GROUP	MODEL
BOD	2020-2025MY Soul (SK3)
NUMBER	DATE
337 (Rev 1, 9/10/2025)	March 2025

TECHNICAL SERVICE BULLETIN

SUBJECT: **HORN ASSEMBLY INSPECTION/REPLACEMENT (WTY041)**

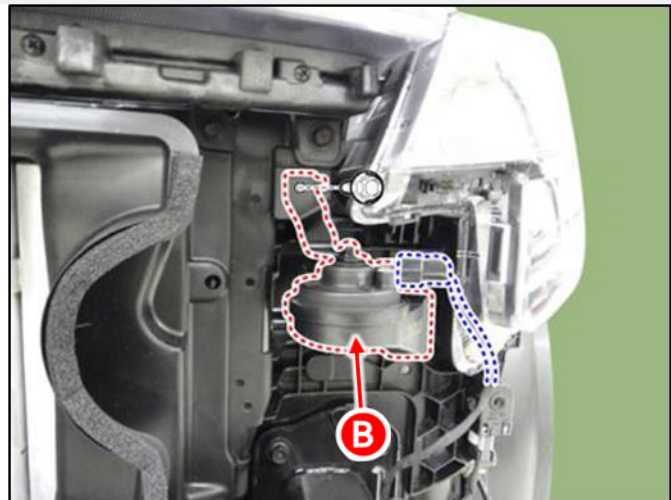
- Press the Horn Pad (A) to confirm normal operation:
 - If the horn operates **normally**, this TSB does not apply. **Claim inspection only labor op 242200R0.**
 - If the horn is **inoperative** or the **tone is distorted**, proceed to the 'Replacement Procedure' below.

- Replace the Horn (B) by referring to "Body Electrical System → Horn → Repair procedures" in the applicable Shop Manual on KGIS.

- Reinstall all removed parts in the reverse order of removal.
- Confirm normal operation.
